Addendum No: One (01)

Project: Sedalia Downtown Streetscape Phase IV

Project No. 2019-03

Date: June 27, 2019

Existing trees not designated for removal shall be protected from damage during construction. Trees damaged during construction shall be pruned and wounds protected as approved by the City's Representative.

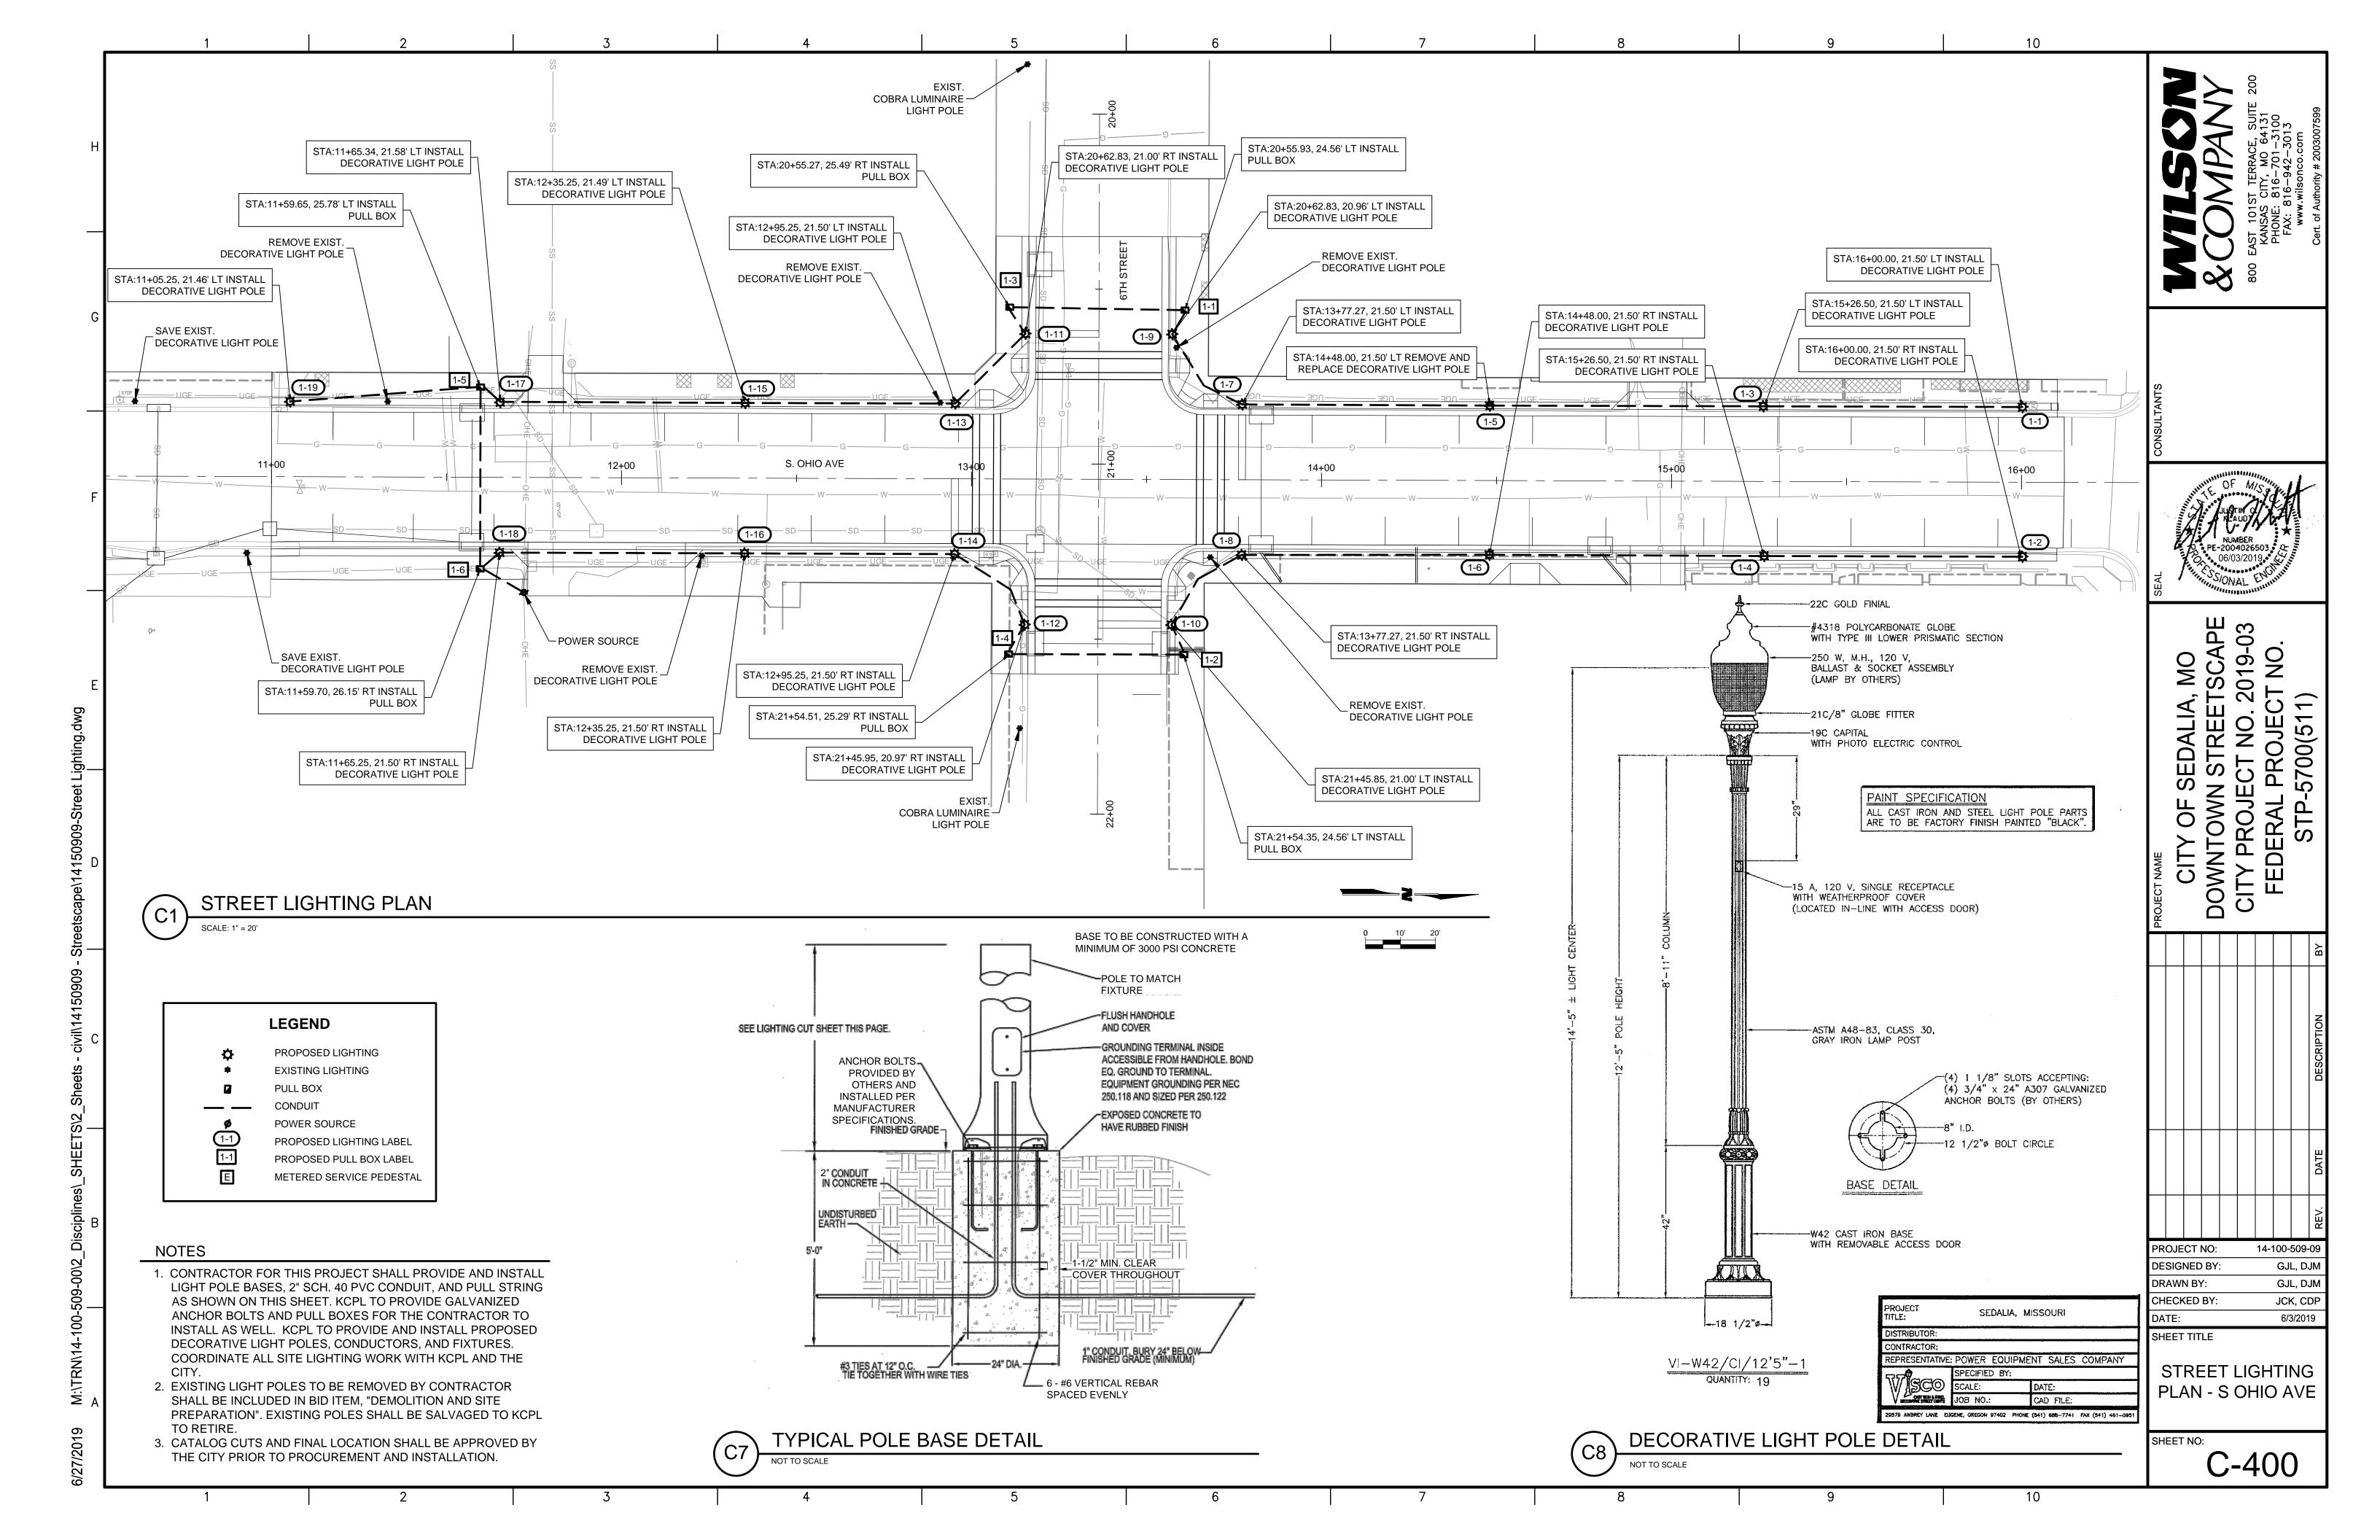
- a. C-000 TITLE SHEET
 - i. Removed Traffic Signal Sheets from Index of Sheets.
 - b. C-001 GENERAL NOTES & SUMMARY OF QUANTITIES
 - i. Removed Traffic Signal Bid Item and Decorative Metered Service Pedestal from Summary of Quantities and added Bid Item "No Parking Zone Line".
